CRUISER  
AIRCRAFT

## SERVICE BULLETIN

No.: SB-CR-087

<b>MODEL</b>	PS-28 Cruiser
<b>AFFECTED:</b>	SportCruiser / PiperSport operating under EASA rules
<b>SUBJECT:</b>	Substitution of Trail Tech light
<b>AIRCRAFT</b>	All PS-28 Cruiser aircraft
<b>AFFECTED:</b>	All SportCruiser / PiperSport operating under EASA rules
<b>COMPLIANCE:</b>	According to the owner's decision.

Fig. 2: Oval hole

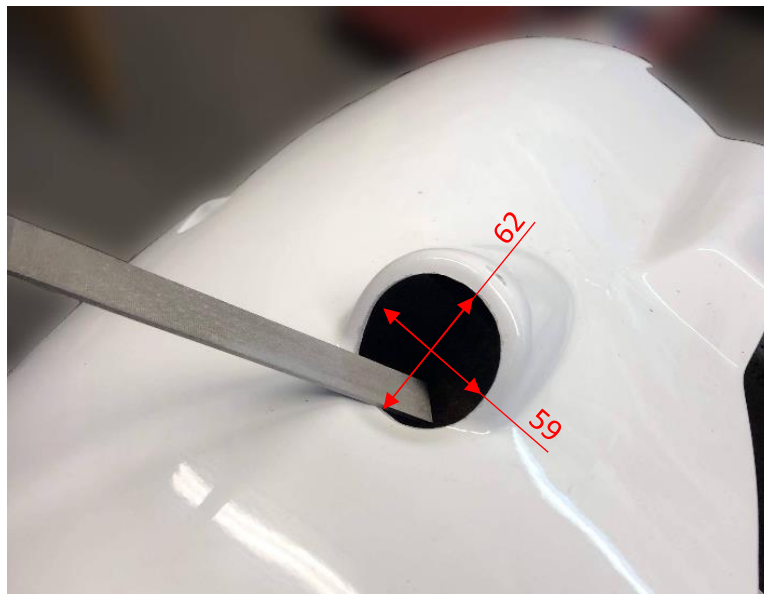
5. Using a mock-up, drill a 2.5 mm hole. Then drill the hole to a diameter of 5.2 mm.
6. Depending on the resulting joint thickness, choose a suitable screw (004 or 005) and a combination of washers (007 and 008).
7. Test light (001) and verify the parallelism of the front of the light and the flange in the cowling after tightening the bolt. Due to the tightening of the screw, the parallelism may be broken. In this case, choose another pad.
8. If necessary, repeat steps 5 to 7.
9. Enlarge the front hole for the light to an oval with dimensions 62x59mm (see Fig. 2).

NOTE: Slight overlap between top of light lens and cowling is acceptable (approx. 5 mm).

Fig. 3: Electric scheme

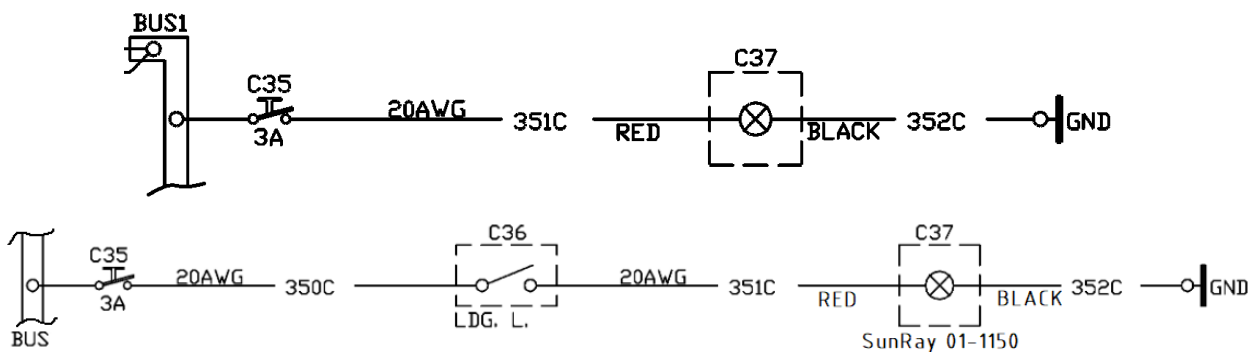
10. Degrease the surfaces where the adhesive will be applied.
11. Glue the pad with glue (012 or 013). Before the glue hardens, the position can be checked and adjusted using a mock-up. To fix the glued joint, use a screw and a nut (006). Protect the screw against sealing with plastic foil and vaseline.
12. Clean the drilled hole from glue residues.
13. The light has 5 wires, only two will be used. Red 351C (positive) and black 352C (ground), blind the other wires with a shrink tube (010). See Fig. 3. Valid scheme depends on airplane equipment.
